service bulletin

No. 89-12

- A. 15 HP Idle Quality
- B. Propeller Rubbing, Stalker-Thruster 12/24
- C. 1989-1/2 Mariner 40 HP (2 Cyl.) RFI Spark Plug Boots
- D. 1989-1/2 Mariner 40 HP (2 Cyl.) Ignition Specifications
- E. 6, 8, 9.9, & 15 HP Exhaust Relief Holes

E. 6, 8, 9.9 & 15 HP EXHAUST RELIEF HOLES

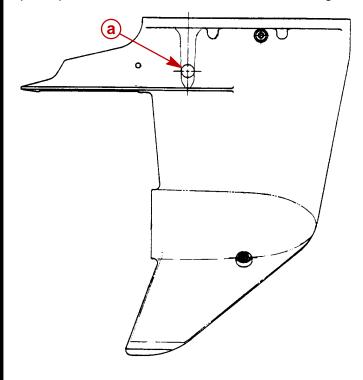
Exhaust relief holes in gear housing are required, when using sail/work boat propellers for high reverse thrust applications.

Drill two 1/2" (12.5mm) diameter exhaust relief holes (a) (1 each side) into gear housing, as shown. A dimple is provided at this location for ease of drilling.
